# CITY OF ALBUQUERQUE

**RE: 3409 Herrera Rd. NW  
3409 Herrera Rd. NW  
Grading and Drainage Plan  
Engineer's Stamp Date: 2/4/22  
Hydrology File: F17D026A**

Based upon the information provided in your submittal received 2/4/22, the Grading & Drainage Plan **is not** approved for Building Permit. The following comments need to be addressed for approval of the above referenced project:

ENGINEER'S SEAL	3409 HERRERA	DRAWN BY WCVWJ
	GRADING AND DRAINAGE PLAN	DATE 2-03-22
		2022009-LAYOUT-2-03-22
2/4/22	 <i>Rio Grande Engineering</i> 1606 CENTRAL AVENUE SE SUITE 201 ALBUQUERQUE, NM 87106 (505) 872-0989	SHEET #  —
DAVID SOULE P.E. #14522		JOB # 2022009

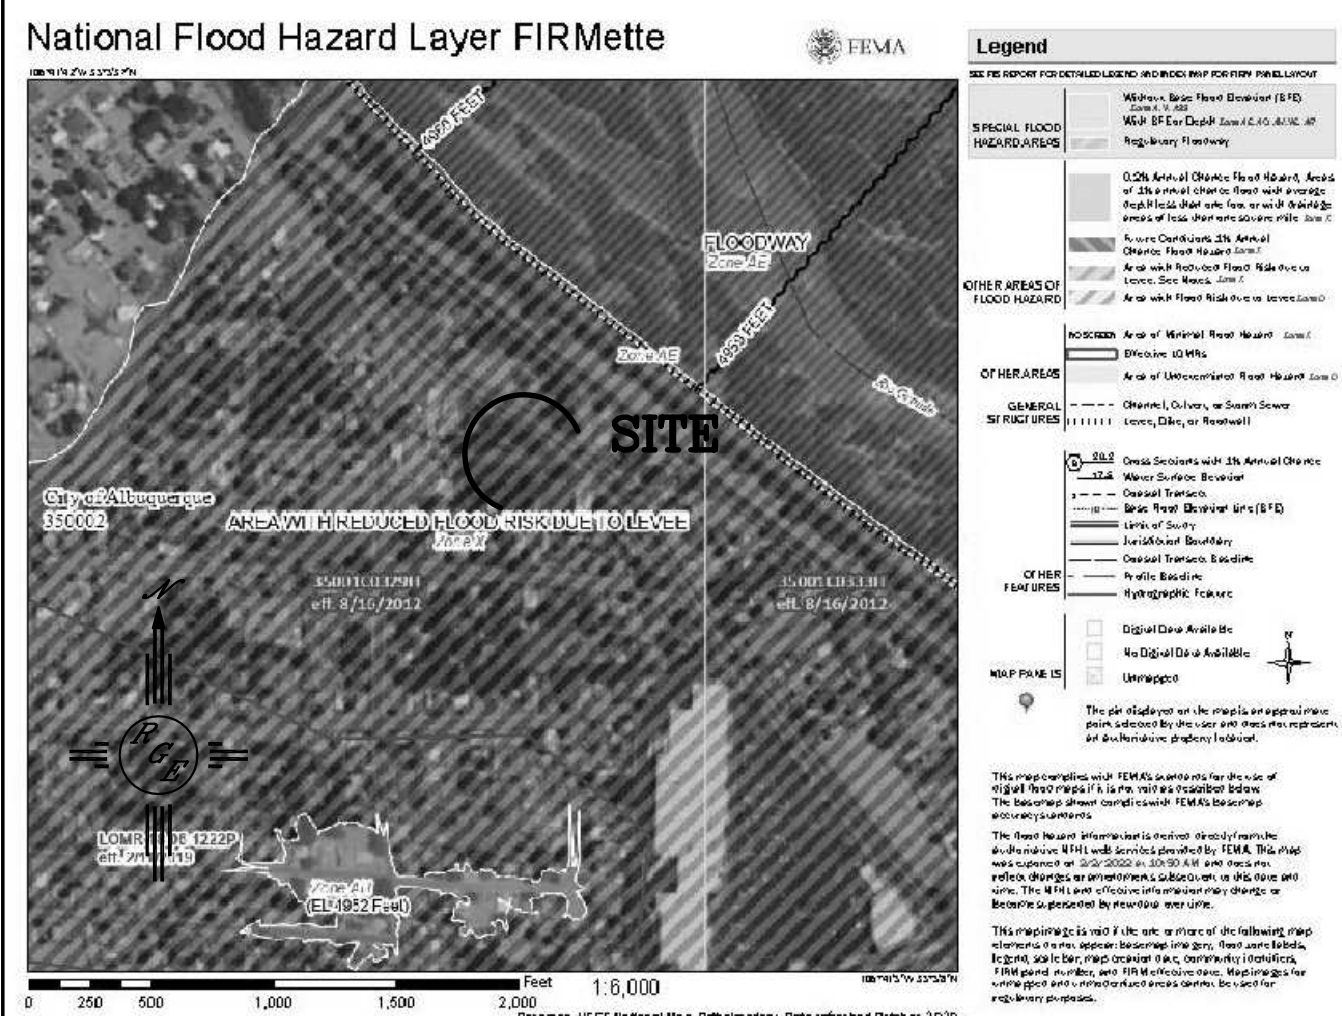
1. Please review the calculations. I do not see where you came up with the 4690 cf of volume. One pond is 1573, one 681 and existing 185 as shown on the plans. That adds up to 2439 cf.
2. Please update as no first flush is required for residential.
3. Please enlarge the text for the calculations and summary/narrative.
4. Would it make sense to connect the ponds and allow discharge out to the roadway. Should these be detention ponds? For retention, please calculate the 10 day volume for the 100 year storm and provide that storage.
  - a. For retention, the site must collect all of the flow.
5. Please show enough points to ensure no flow will go to neighboring sites. Driveway area is not clear.
